SUBJECT: Advises that util will equip temporary filtration sys w/
 electric heater for purpose of humidity control to provide
 addl assurance that sys will perform at required levels of
 efficiency, per NUREG-0737, Item III. D. 3. 4.

L-86-464

Re: Turkey Point Units 3 and 4
Docket Nos. 50-250 and 50-251
Proposed License Amendment
Control Room Ventilation

TEMPORARY CONTROL ROOM HVAC SYSTEM

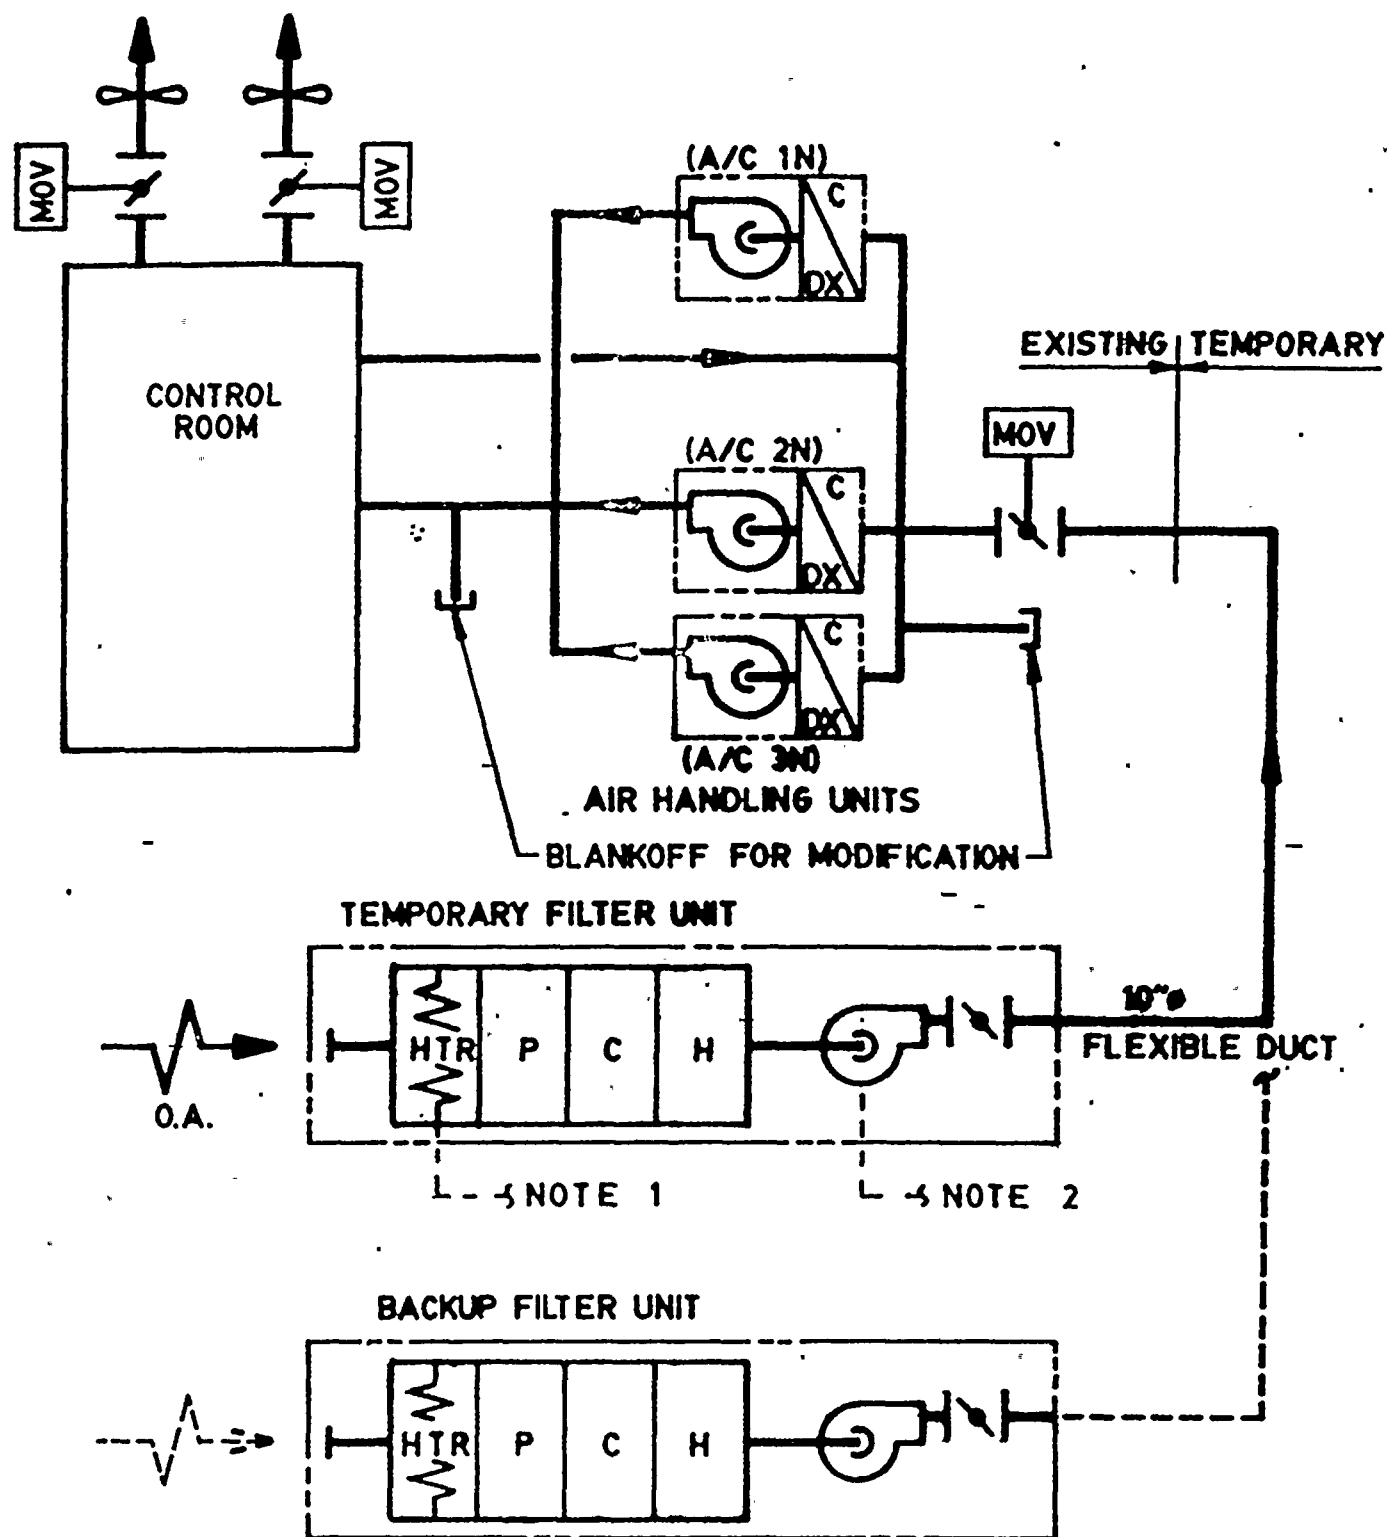
Because of questions raised during an engineering review of vendor information regarding capability of the temporary filtration system to remove iodine above 70% humidity, FPL intends to equip the system with an electric heater for the purpose of humidity control to provide additional assurance that the temporary filtration system as discussed in the NSHE will perform at the required levels of efficiency under Turkey Point site environmental conditions. The electric heater, which will be installed at the fresh air intake to the temporary filter unit (See the attached figure), will ensure that the iodine removal efficiency of the downstream charcoal adsorber will be maintained at acceptable levels during periods of high humidity. The electric heater will be designed for automatic operation with a relative humidity sensing device and control circuit set to energize the heater when the air relative humidity exceeds 70 percent.

Under normal conditions, power to the electric heater will be supplied from an existing non-vital plant bus. However, to ensure operability of the heater under loss of offsite power conditions, a dedicated, non-safety grade portable diesel generator will be available to serve as a backup source of power which will start automatically on low voltage to the bus feeding the heater. This backup diesel generator will be capable of continuous operation for up to 40 hours without refueling. Under accident conditions, operation of the backup diesel generator and the temporary system heater for 40 hours is sufficient to ensure acceptable performance of the charcoal adsorber to maintain the control room operators exposure dose to within GDC-19 limits.

The addition of this electric heater and its associated diesel generator power supply will enhance the performance of the charcoal adsorber during periods of high humidity. Operability of these components and their associated actuation and control circuitry will be demonstrated by appropriate functional testing prior to use. Therefore, this design enhancement will not alter the conclusions of the NSHE provided in our August 25, 1986 submittal.
